This is to certify that LANDMARK HEALTHCARE FACILITIES LLC / Ledgewood

has permission to Establish the use of 2nd & 3rd floor for as offices w/ tenant fit-up

AT 10 FORE RIVER PKWY 2nd & 3rd Floor CE 075 A00500

Re: Fore River Medical Pavilion  
2<sup>nd</sup> & 3<sup>rd</sup> Floor Tenant Improvements  
Response to Review Comments

Third Floor Plan

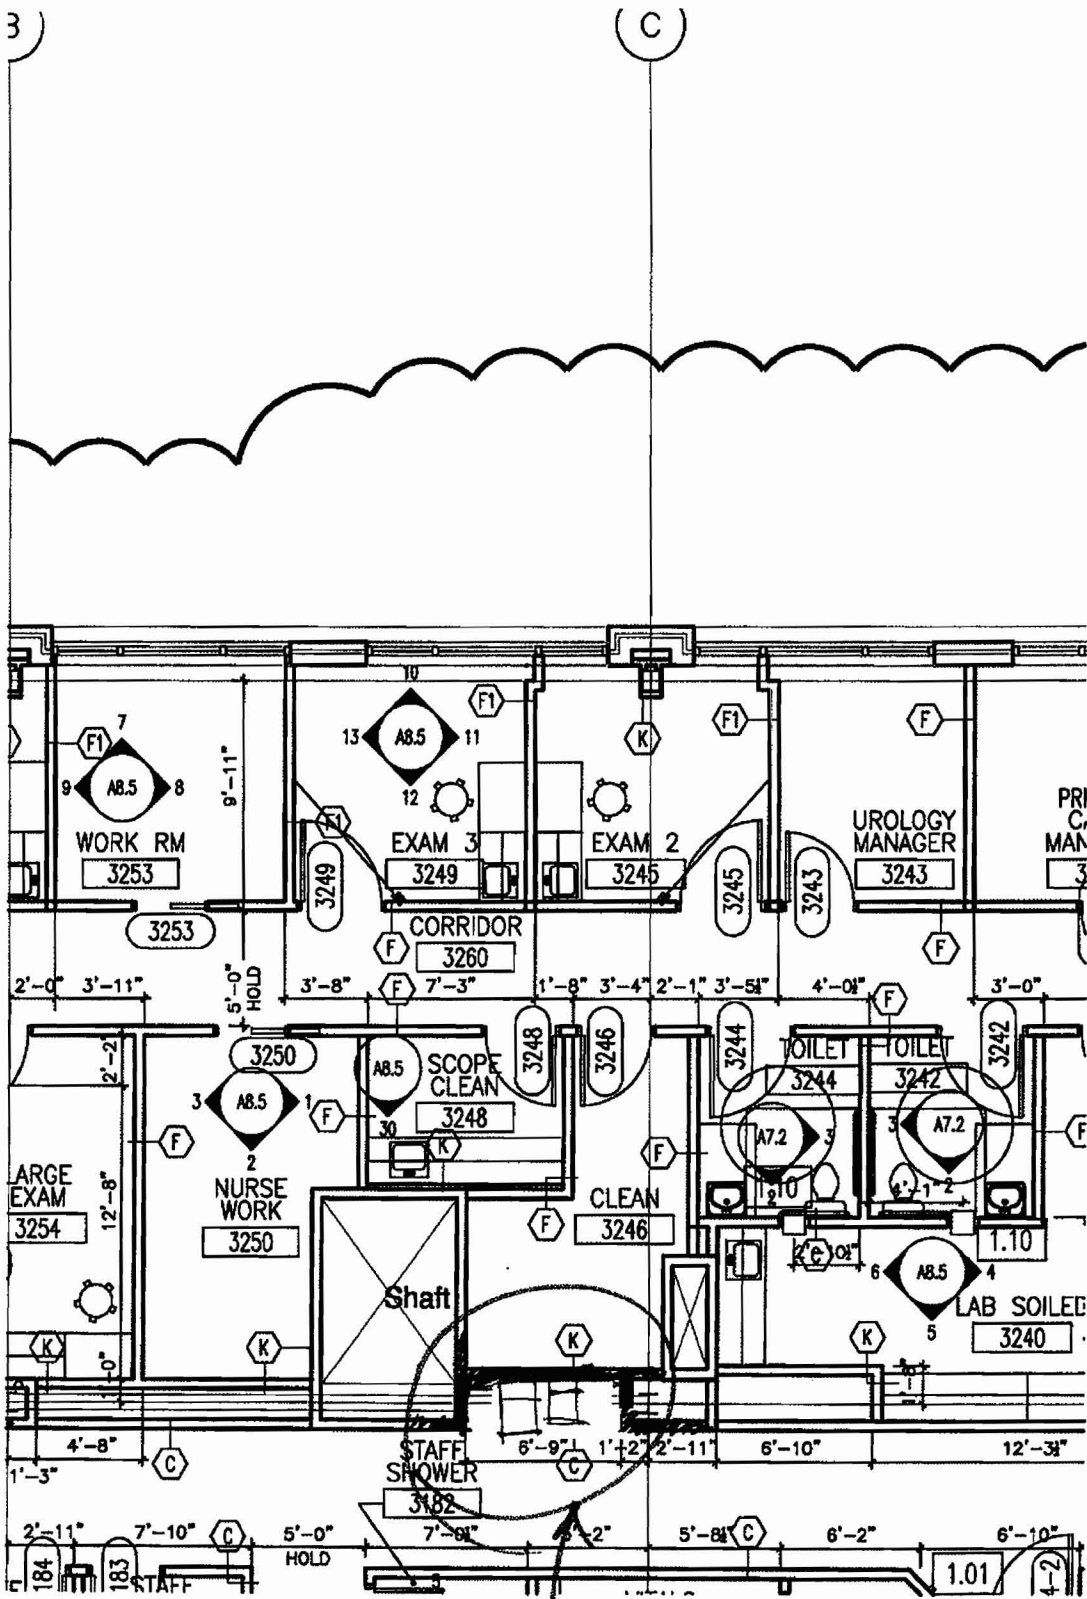
Thanks for the letter, the only item we discussed that is not addressed is the gender ID for the bathrooms, specifically where there are 2 bathrooms grouped in one reception or clinical area, or where there are 2 staff bathroom groupings.

Also, an item I just came across, there should be one drinking fountain per occupied floor. See Table 4-1.

As far as the drinking fountain, we have on the 2<sup>nd</sup> floor to the right of doors 2010-2. We forgot to show the one on the third floor but I have attached a sketch of where it will be located (see attached PDF).

electric water cooler location
